**McDonnell Douglas
Helicopter Company**
SERVICE INFORMATION LETTER

LETTER NO HL-30
DATE 12 JULY 1973
PAGE 1 OF 2

SUBJECT: REPLACEMENT OF BOOM FAIRING ASSEMBLY ON FIRST
PRODUCTION HELICOPTERS, SN 0001 THRU 0100

MODELS AFFECTED: 369H Helicopter Serial No. 0001 thru 0005
369HS Helicopters Serial No. 0001S thru 0100S
369HM Helicopter Serial No. 0001 thru 0004;
0005M thru 0100M

Figure 1. Modification and Replacement of Boom Fairing Assembly

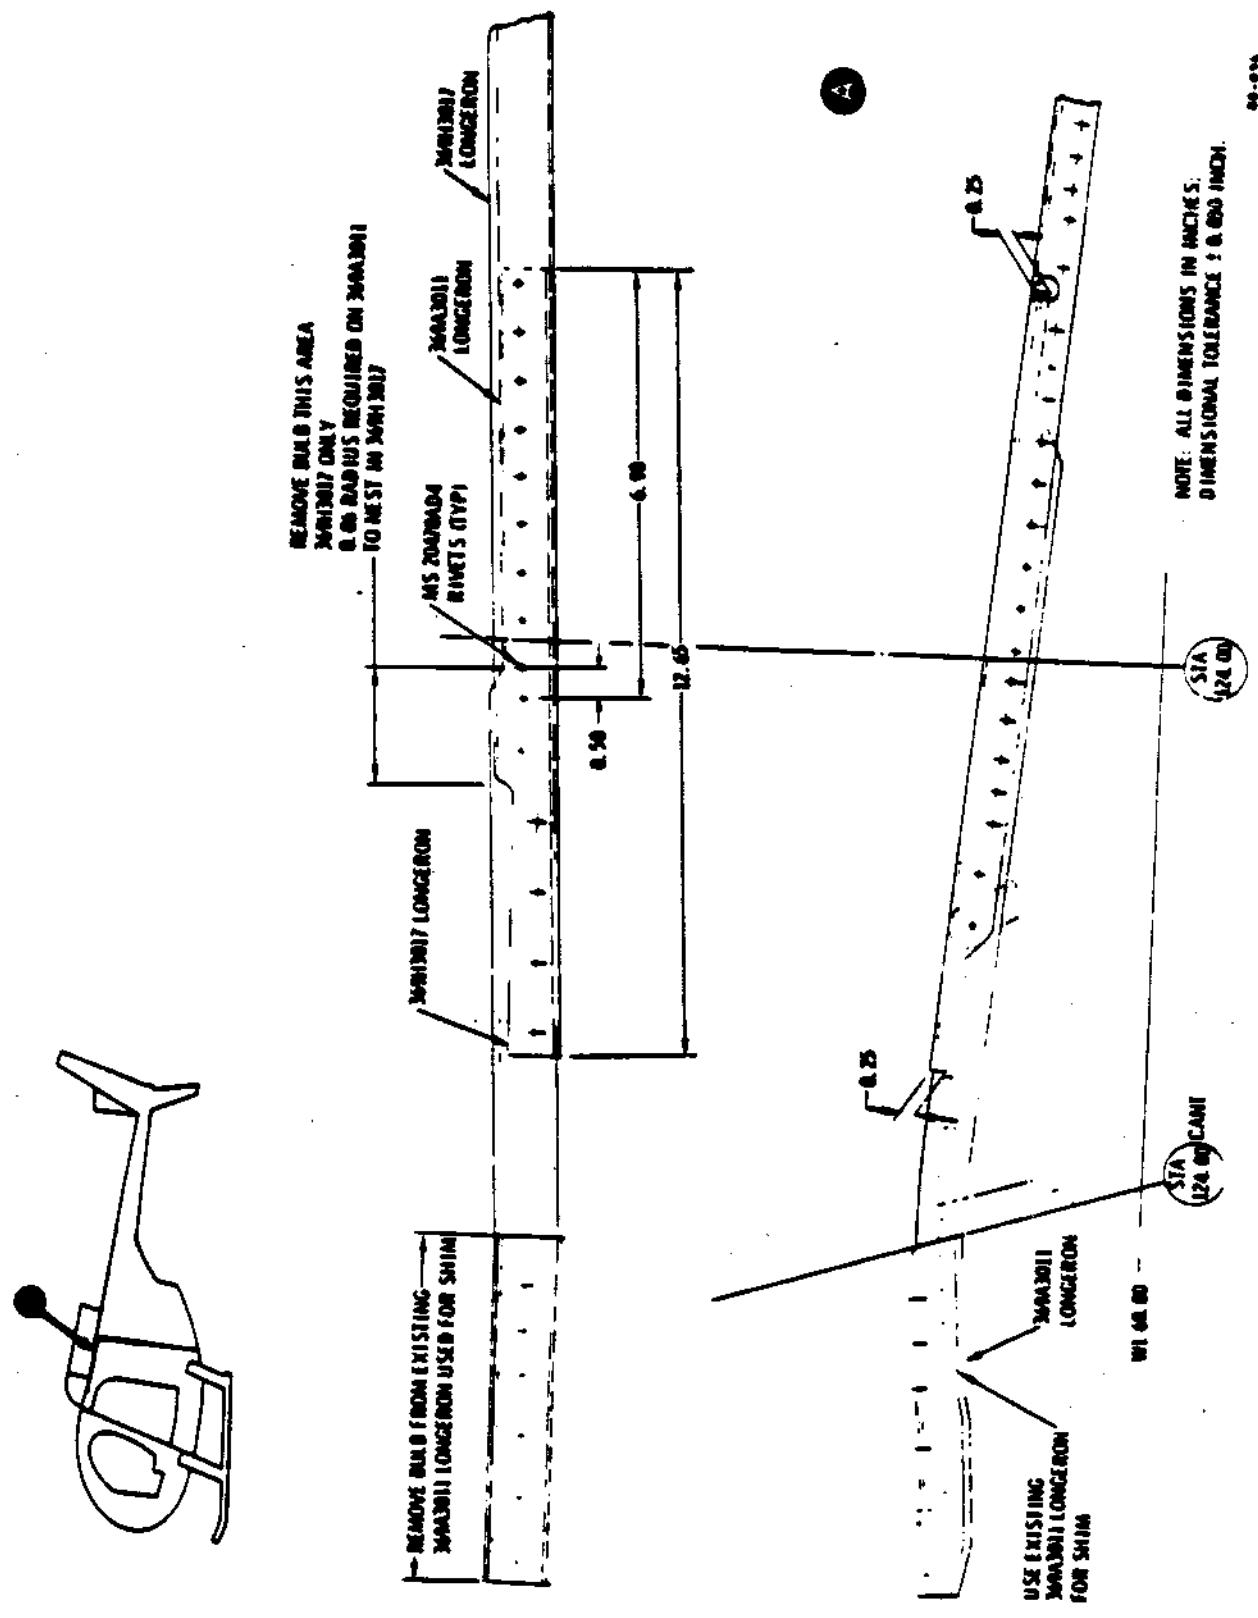
Due to the difference in design of the mast support structure used on the above affected first production helicopters, it is necessary, when installing a replacement boom fairing assembly, to modify and lengthen the 369H3017 upper longerons to permit attachment at the mast support structure.

The method for extending the 369H3017 upper longerons with added sections of 369A3011 longerons is illustrated on page 2 of this letter. As shown, the bulb section of the 369H3017 longeron is removed, and a 0.060-inch radius applied to the added section of the 369A3011 longeron, so that the two pieces will nest together. Also, a section of existing 369A3011 longeron with the bulb section removed is used as a shim at the forward end of the extended 369A3011 longeron, to ensure a proper fit when riveted to the mast support structure. No additional rivets are added to the side of the longerons. The rivet spacing on the top of the longerons at the shim area is increased.
